APPLICATION NO.	FILING DATE	FIRST NAMED INVENTOR	ATTORNEY DOCKET NO.	CONFIRMATION NO.
10/642,547	08/15/2003	Markus Hammes	L&L-10024	1990
24131	7590	10/31/2006	EXAMINER	
LERNER GREENBERG STEMER LLP			WARE, CICELY Q	
P O BOX 2480			ART UNIT	PAPER NUMBER
HOLLYWOOD, FL 33022-2480			2611

Office Action Summary	Application No.	Applicant(s)	
	10/642,547	HAMMES ET AL.	
	Examiner	Art Unit	
	Cicely Ware	2611

DETAILED ACTION

Fig.1
PRIOR ART

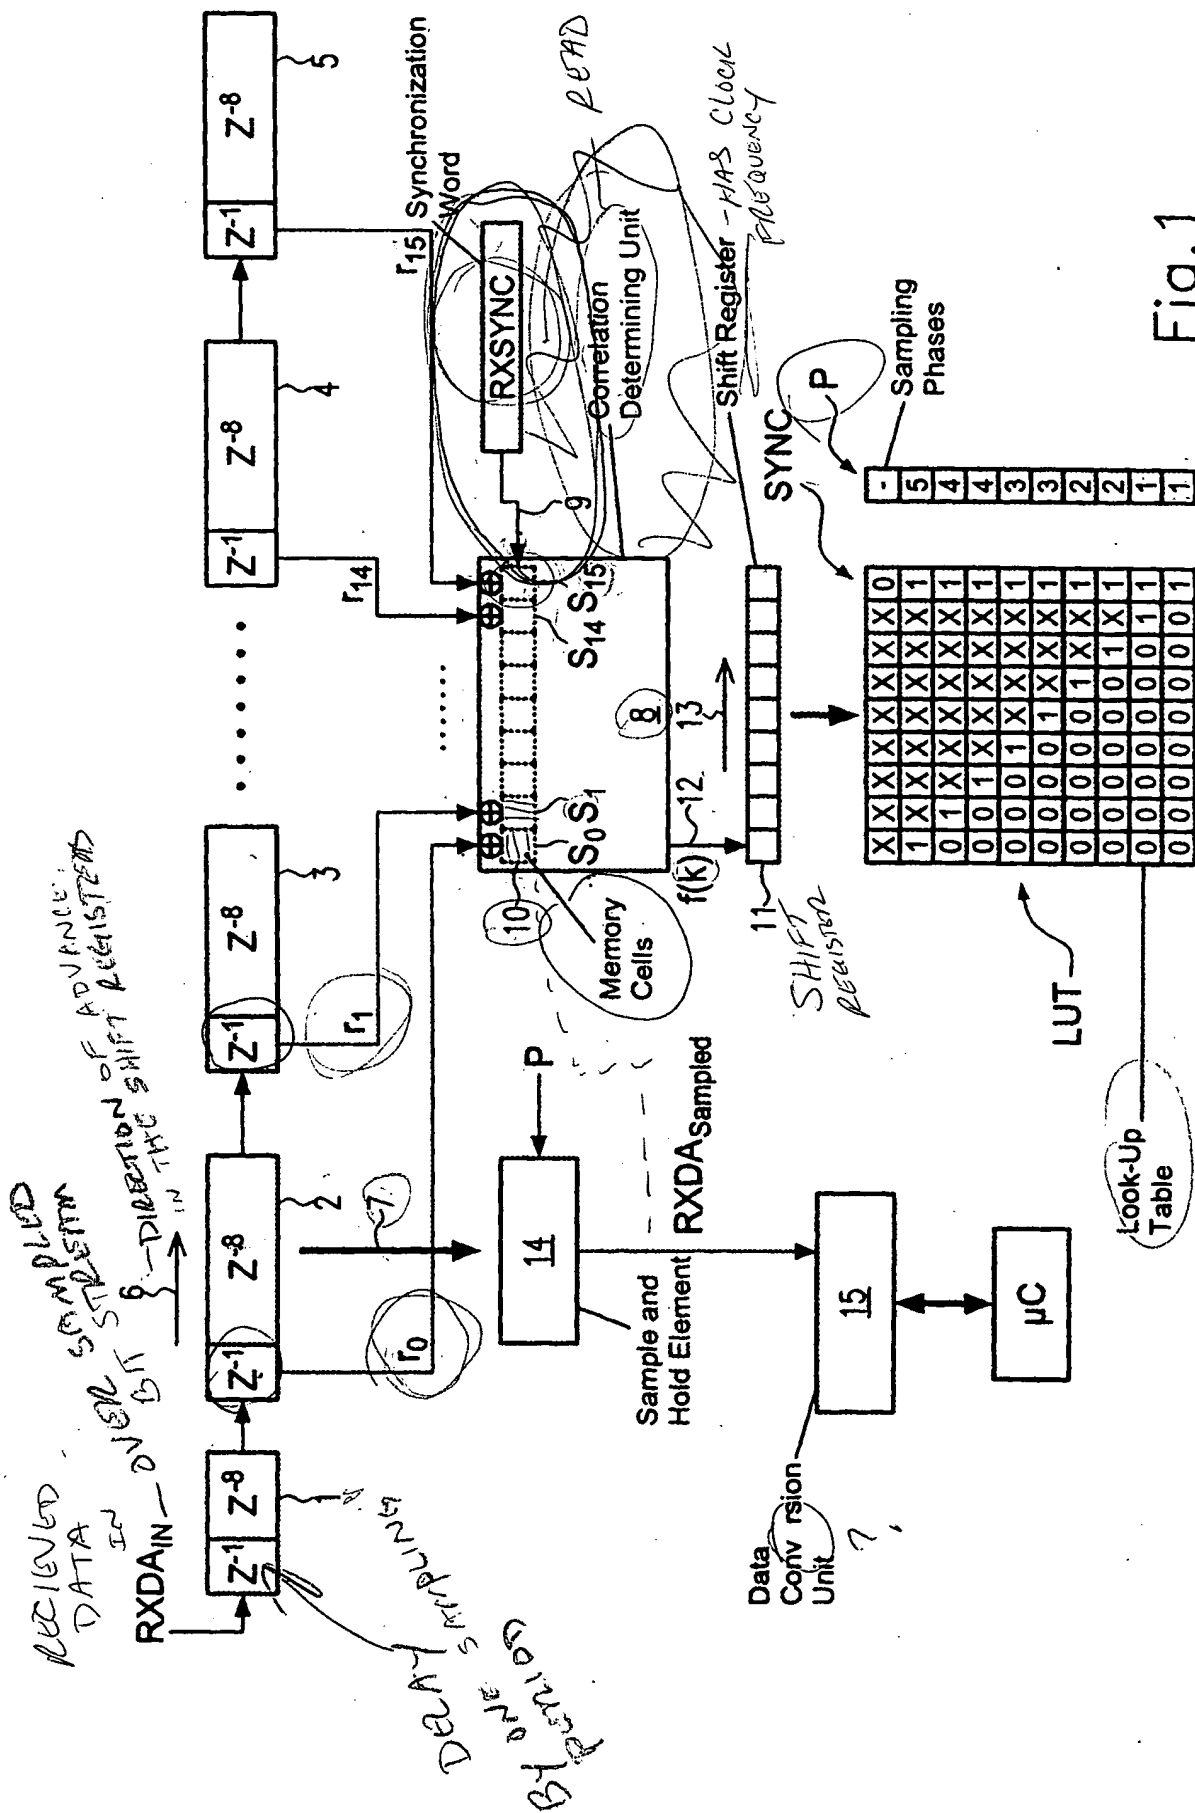
a. Fig. 1, element 15, applicant uses "Data Conv rsion Unit". Examiner suggests using "Data Conversion Unit" for clarification purposes.

4. Claims 1-3, 8-14, 19-22 are rejected under 35 U.S.C. 102(b) as being anticipated by Applicant's Admitted Prior Art (Fig. 1).

(1) With regard to claim 1, Applicant's Admitted Prior Art discloses in (Fig. 1) an apparatus for ascertaining and correcting an optimum sampling time for an oversampled digital stream in which samples are taken at n different sampling times for each bit, the apparatus comprising: a reading unit (7, 8) for reading each next digital bit stream at said optimum sampling time (Pg. 2, lines 22-26- Pg. 3, lines 1-5, Pg. 16, lines 11-25); a correlation determining unit (8) for determining a correlation between a sequence of sampled data bits and a comparative sequence (9), said correlation determining unit providing correlation values by determining an associated correlation value at each sampling time; and a unit (11) for determining a new optimum sampling time from said

Examiner asserts that the comparative sequence is the synchronization word of Fig. 1, because it is used by the correlation determining unit to compare with the memory cells.

Applicant's Admitted Prior Art further discloses in (Fig. 1) a comparative-sequence shift register (10) for storing said comparative sequence; said bit read at said optimum sampling time being fed into comparative-sequence shift register (8, 10).

Examiner asserts that the comparative-sequence shift register is the memory of (Fig. 1 (10), because it stores the synchronization word which is the comparative sequence.

Applicant's Admitted Prior Art further discloses in (Fig. 1) a sequence of shift registers (1-5) for shifting said oversampled digital bit stream; each one of said shift registers having n register cells (Z) for holding n samples available for each bit.

Applicant's Admitted Prior Art further discloses in (Fig. 1) wherein said unit for determining said new optimum sampling time (8) determines said new optimum sampling time by considering a sampling-time range (Pg. 17, line 25 (equation discloses a range related to the hamming distance)) within which said hamming distance is below said prescribed threshold value (Pg. 17, lines 6-25).
